# The Proposed Corrib Onshore System An Independent Analysis

# **Prepared for the Centre for Public Inquiry**

Richard B. Kuprewicz President, Accufacts Inc. kuprewicz@comcast.net October 24, 2005

FIGURE 7. PIPE FAILURE HOOP STRESS VS. CORROSION FLAW SIZE – EXTERNAL CORROSION RATE OF 0.254 MM/YR (0.0098 INCH/YR)

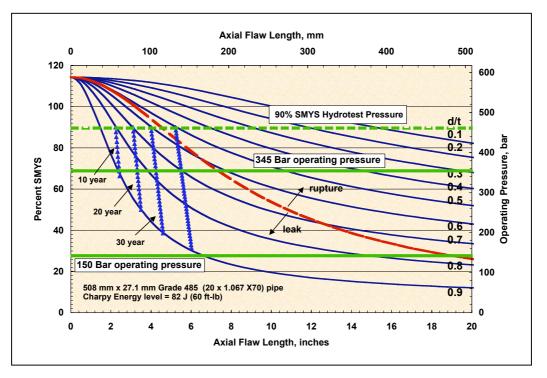
A similar prediction for external corrosion of the Corrib pipeline can be developed as indicated in Figure 7. The parameters are the same as that described for Figure 5 with the exception that external corrosion rate for the one-year growth triangles is calculated using 0.25 mm/yr corrosion rate (or one tenth the rate of internal corrosion illustrated in Figure 5). External corrosion rates typically range from 0.152 to 0.305 mm/yr (0.006 to 0.012 inches/yr). A corrosion rate of 0.25 mm/yr would be a conservative rate for a well-coated new pipeline.

Comparable observations can be made from Figure 7 that were followed for Figure 5. The major point is that thick-walled pipe is not invincible from external corrosion attack failure, though because of the much slower rates, time to failure is much greater. We have a higher degree of confidence in estimating external corrosion rates for a new pipeline, but a much lower degree of confidence (if any) that internal corrosion rates will be as low as implied by previous publicly released documents for this proposed pipeline.

Following an approach similar to that described in Figure 5 and looking at the left most column or series of triangles, a flaw initiating at a d/t of .8 with a length of slightly over fifty mm (two inches) could have survived the hydrotest and would be expected to grow for approximately 10 years and still be able to just survive an operating pressure of 345 Bars. While not indicated, this same flaw could take an additional 20 years of external corrosion (for a predicted service life of 30 years) before it failed if pressure were limited to a maximum of 150 Bars. Failure of this specific anomaly at 150 Bars would be as a leak.

From this figure it should be concluded with a high degree of confidence that external corrosion would not be a primary risk of concern for this pipeline. This observation assumes that the appropriate cathodic protection is made operational in a timely manner, and close interval surveys are properly undertaken to ensure no external selective corrosion "hot spots," where external corrosion rate could be accelerated, develop over the life of the pipeline. Close interval surveys employ various above ground inspection techniques to periodically determine the effectiveness of the CP system and pipeline coating to resist external corrosion on a pipeline.

FIGURE 12. CORRIB ONSHORE PIPELINE RUPTURE THERMAL FLUX VS. DISTANCE FROM PIPELINE 150 BAR CASE

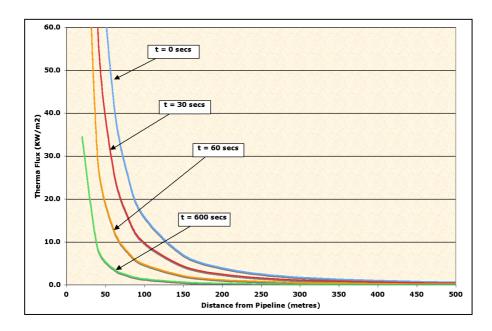
Figures 12 and 13 indicate energy release or thermal flux (in KW/m<sup>2</sup>) as a function of distance from the pipeline for the Corrib onshore pipeline estimated for the boundary condition pressures of 150 Bar and 345 Bar, respectively. The two graphs represent a full-bore rupture release, corrected for non ideal gas effects associated with high flow turbulence, occurring in the vicinity of the neighboring Rossport homes. An instantaneous ignition curve (t= 0 seconds) and delayed ignition at various other times have also been estimated for reference. The thermal flux curves declining as a function of distance is characteristic of any major flame source from a pipeline rupture. The thermal flux decay with time is representative of mass flow degradation from high pressure pipelines. The spread between the time to ignition curves will be a function of pipeline hydraulics, point of rupture, the compressed gas inventory (e.g., density), and response time to close nearby valves.

Figures 12 and 13 only tell part of the overall equation as the thermal flux for a certain distance needs to be translated (estimated from Figures 12 or 13) into a thermal dosage that either causes serious burns, fatality, or dwelling loss. Figure 14 represents a series of thermal dosage models derived from industry accepted thermal models.<sup>15</sup> Figure 14 is a "time to" chart graphically illustrating the time to which a fixed thermal flux can be tolerated for unsheltered

#### FIGURE 15. ROSSPORT 400 METRE RUPTURE IMPACT ZONE

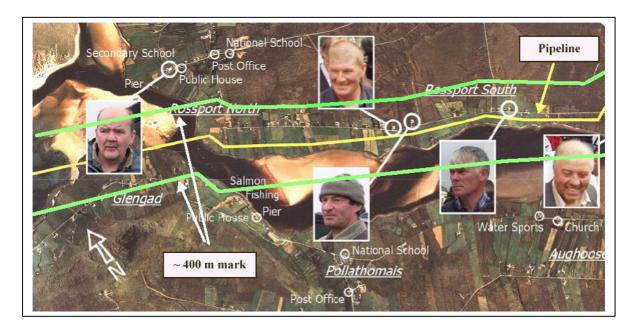
The green band lines in Figure 15 represent an approximate 400 metre zone from the proposed pipeline in proximity to Rossport. Most of the citizens are within the band for unsheltered individuals. Note the large number of dwellings in close proximity to the pipeline well within 200 metres from the pipeline.

FIGURE 18. CORRIB PROPOSED ONSHORE GAS PROCESSING PLANT BASIC PROCESS FLOW SCHEME

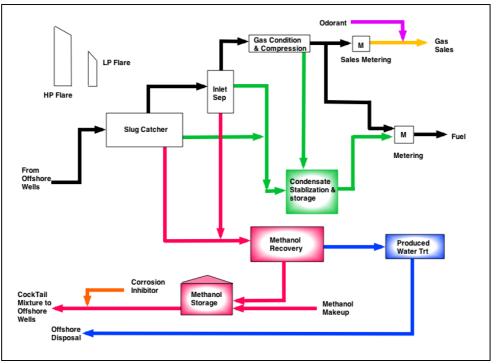
A simplified flow diagram of the terminal proposed at the end of the Corrib pipeline is indicated in Figure 18. The bulk of this equipment is for simple liquid removal for elemental gas drying.

If the Gas Processing Plant were the only equipment to be placed at the onshore site it would be fairly easy to recommend its placement as, relatively speaking, the equipment depicted in Figure 18 is fairly straightforward. The plant is limited in complexity and can be easily judged as to its safety by a basic review of: 1) a plant layout drawing to review major equipment placement and separation, 2) various simple P& ID's, and 3) an analysis of the HAZID.<sup>30</sup> The footprint for a simple gas plant is not the large size currently projected (see Figure 3, large red quadrangle), suggesting that other processes may be in future schemes. Given the lack of clarity related to this project to date and demonstrated by this report, it is understandable that the local citizens have little confidence in denials concerning future expectations for this site. It is beyond the scope of this report to analyse all possible additional infrastructures that could be sited, but it would not be beyond reason to assume that an oil refinery would be desired in close proximity to a reliable gas source. It is usually the responsibility of local governments overseeing land use planning to properly communicate the possible future infrastructure that a new energy supply brings to the area. Future site plans or alternatives for the proposed onshore facility should be clearly communicated.
